**PREVOST**

**WARRANTY  
 BULLETIN**

Wb09-16

<b>DATE :</b> NOVEMBER 2009	<b>SECTION :</b> 23 - Accessories
<b>EXPIRATION:</b> NOVEMBER 2011	
<b>SUBJECT :</b> AUTOMATIC FIRE DETECTION AND SUPPRESSION SYSTEM (AFSS) - REROUTING LINEAR THERMAL DETECTOR (LTD)

**ADDITION OF 2 TURNS OF TAPE 564099  
ONTO THE TUBE NEAR ITS SUPPORT  
INSTALL A DUAL NYLON CABLE TIE  
ONTO THE TAPE TO PREVENT THE  
CABLE TIE FROM SLIDING OR TURNING**

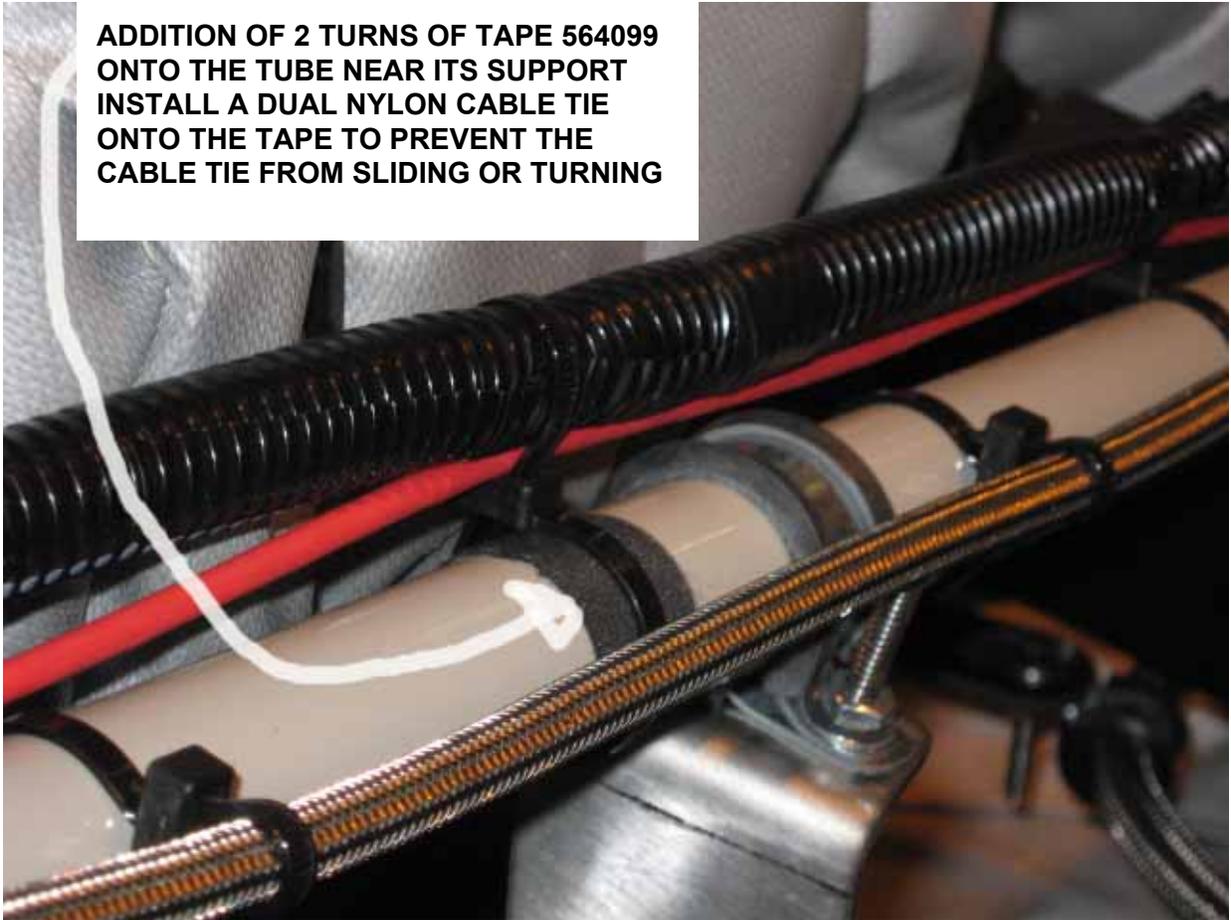
On engine turbocompressor side, on Allison transmission oil level dipstick tube, add two turns of tape 564099 onto the tube near its support and fix linear thermal detector (red cable) by installing a dual nylon cable tie onto the tape to prevent the nylon cable tie from sliding and turning on the tube.

This will prevent the red cable from rubbing against the support.

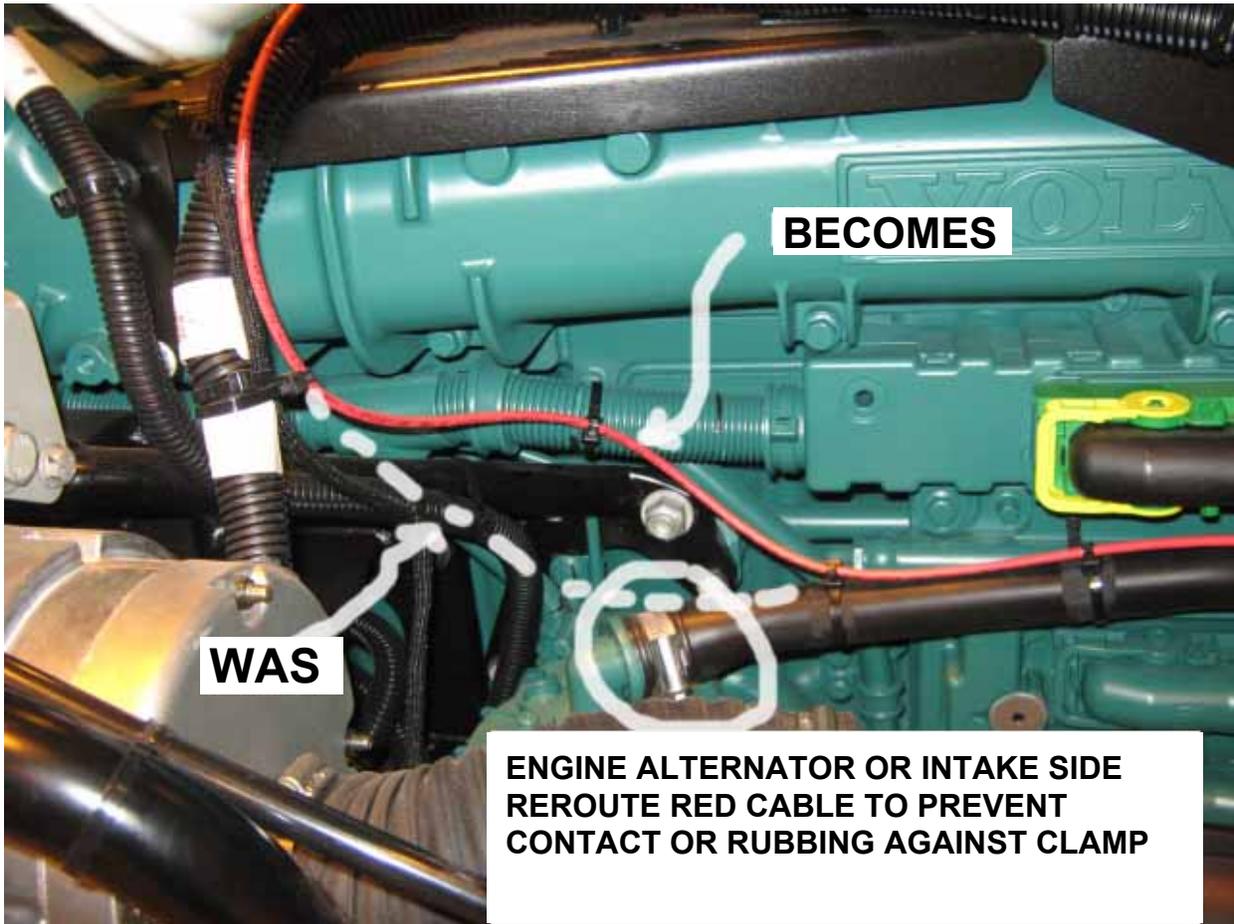
On engine alternator or intake side, reroute linear thermal detector (red cable) to prevent contact or rubbing against clamp. Fix as per picture.
